9.1 NO. 54 (LOT: 7; PLAN: 4387) LINCOLN STREET HIGHGATE – PROPOSED ALTERATIONS AND ADDITIONS TO SINGLE HOUSE

EXECUTIVE SUMMARY:

The purpose of this report is to consider an application for development approval for proposed alterations and additions to a single house at No. 54 Lincoln Street, Highgate (the subject site) that is heritage listed under the City of Vincent's Heritage List (Management Category A). A location plan is included as **Attachment 1**.

1 DEMOLITION - GROUND FLOOR PLAN
SCALE 1:100

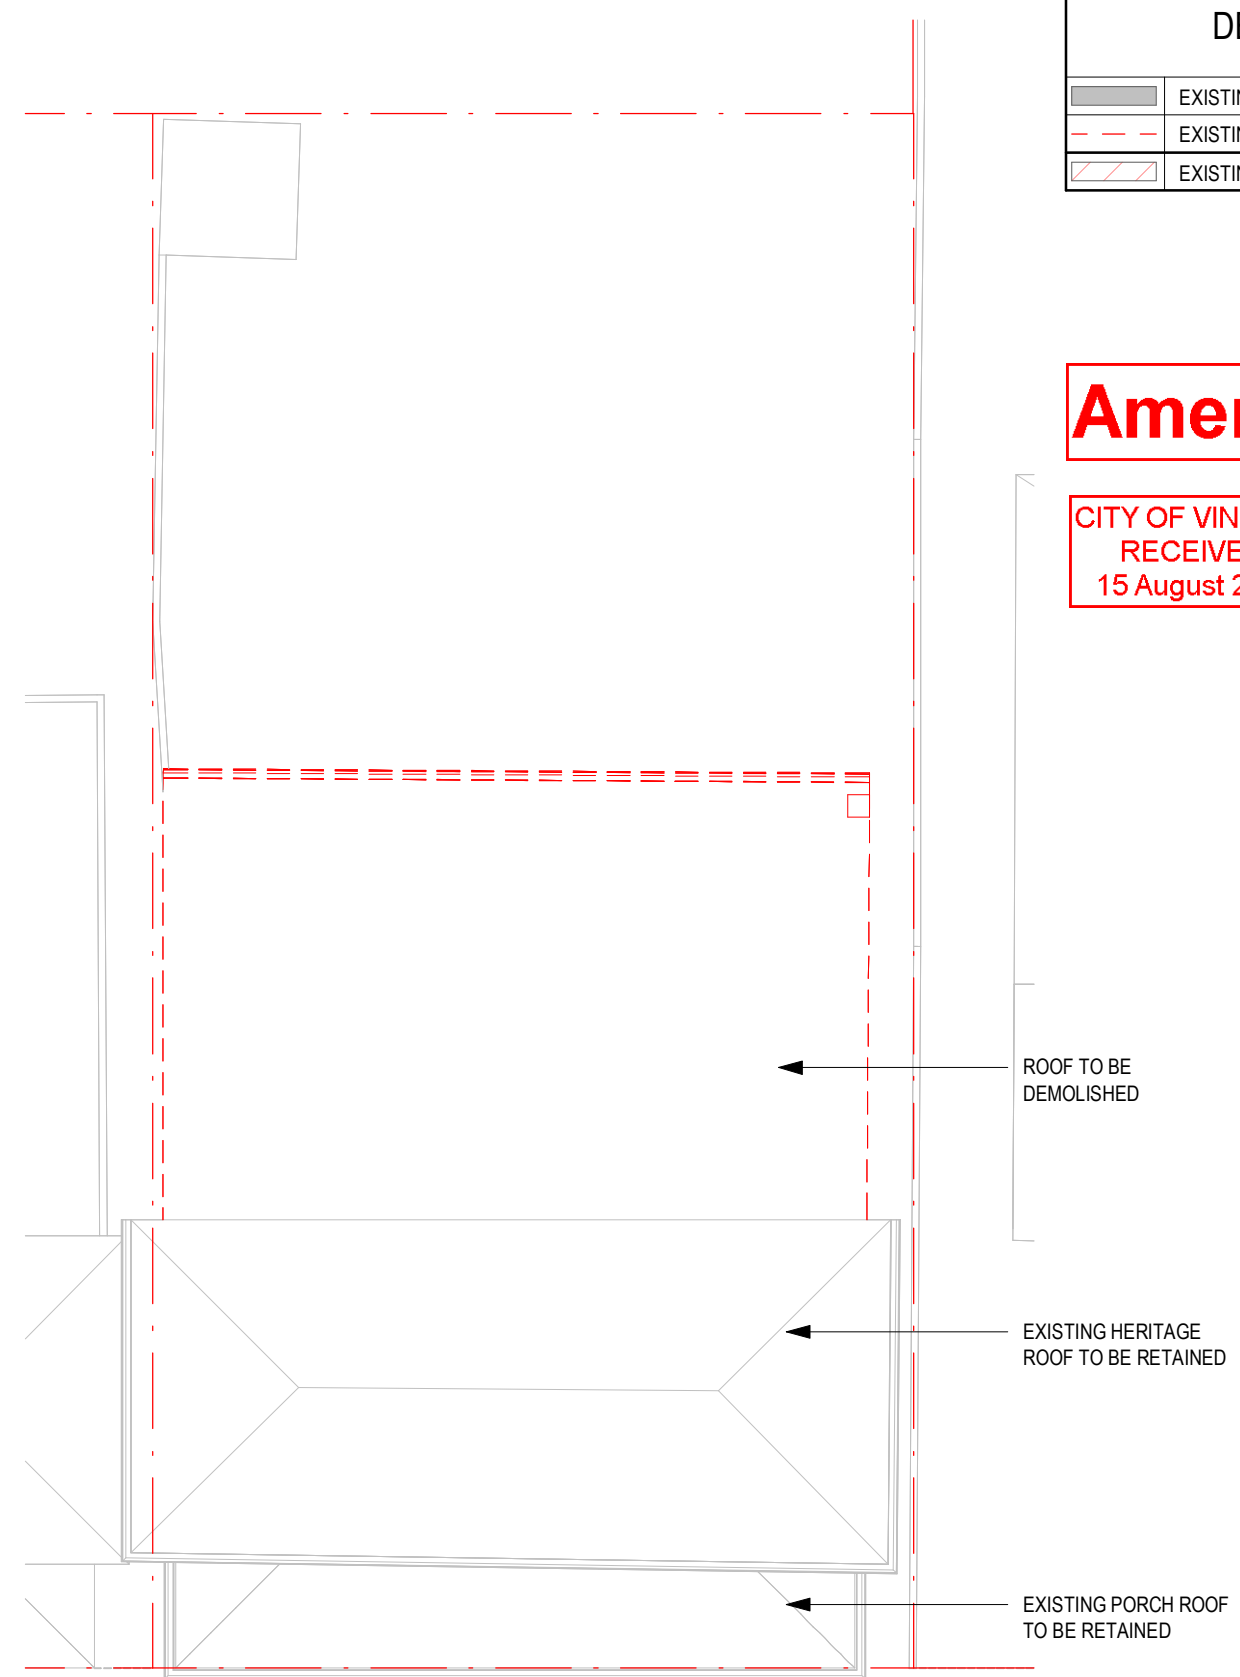
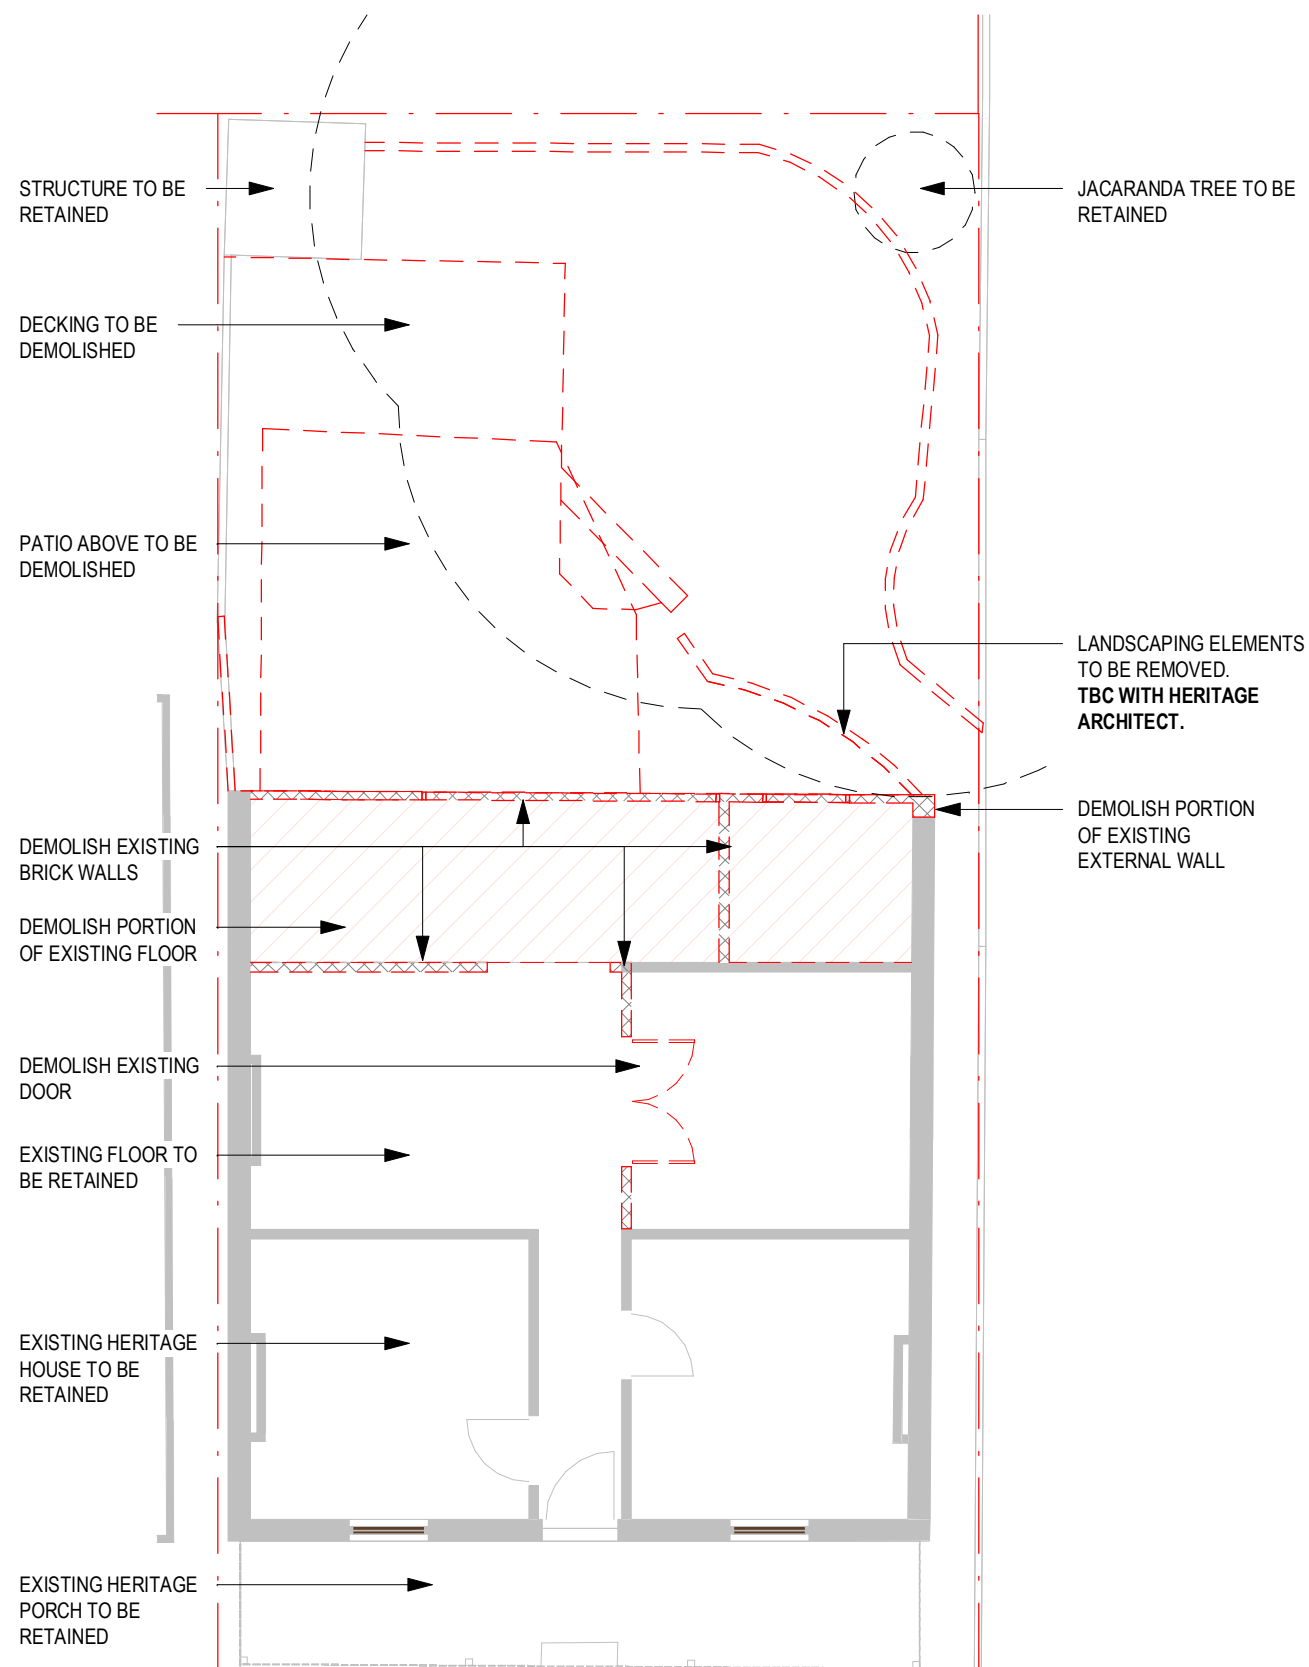
- As a Management Category A place, the proposed alterations/removal of the interior wall from the proposed living to dining room is considered acceptable; however, details of the extent of removal and materials should be provided for the City's consideration.

- As the place is a Management Category A on the Local Heritage Survey, it is recommended that brickwork nibs are retained to each end of the opening as well as to the head of the opening to allow an interpretation that the space was previously two rooms.

Prior to the lodgement of a building permit, amended plans shall be submitted to and approved by the City that show the retention of a frame of brickwork across the ceiling and down the sides of the walls in the demolition of the internal wall between the living and dining rooms. Development and demolition works must be undertaken in accordance with the amended plans approved by the City and prior to use of the approved development, to the satisfaction of the City;

A condition of approval has accordingly been recommended requiring brickwork elements to be retained in accordance with the DRP Member's advice.

Lot Boundary Setbacks

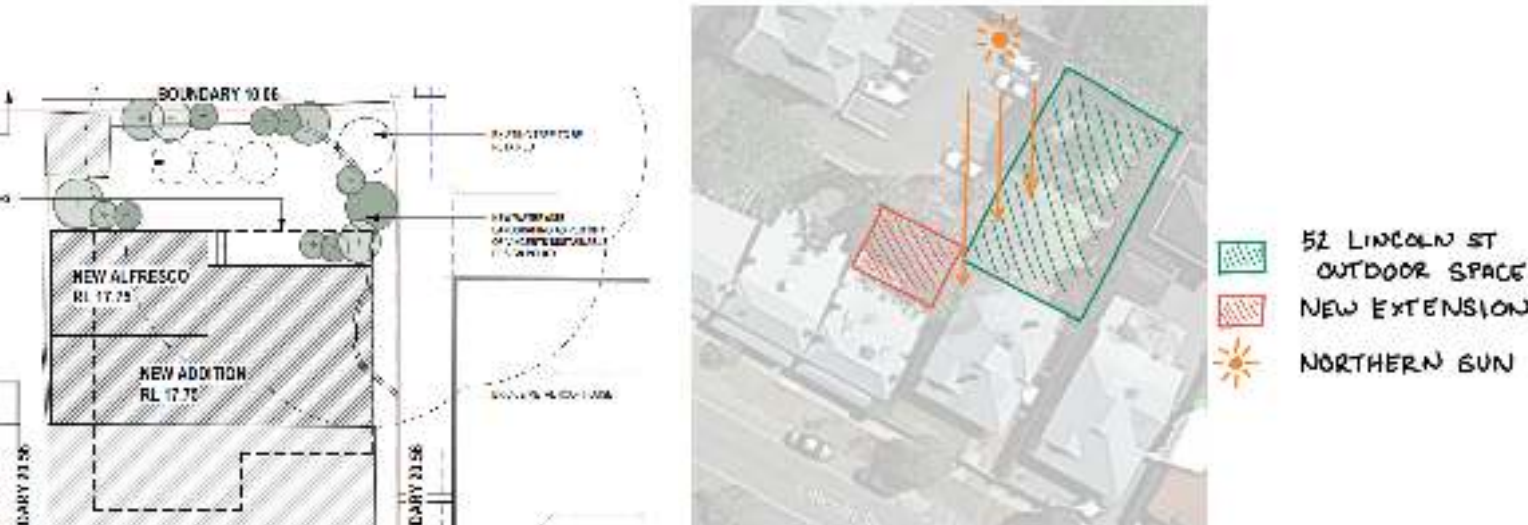
- The western boundary wall height will reduce the amenity of adjoining properties, block sunlight and introduce obtrusively bulky and overbearing mass.
- Reduction to setbacks will impact existing openness and amenity.

The western wall of the extension is stepped in the vertical plane. The lower floor wall follows the line of the existing house which has no material setback as currently built. The upper floor, however, is set back by 1500mm. This ensures that the upper floor does not block light or impact the amenity of the western neighbour. This is demonstrated in the below render showing the location of the western neighbour in relation to the new development (also in application submission documents).
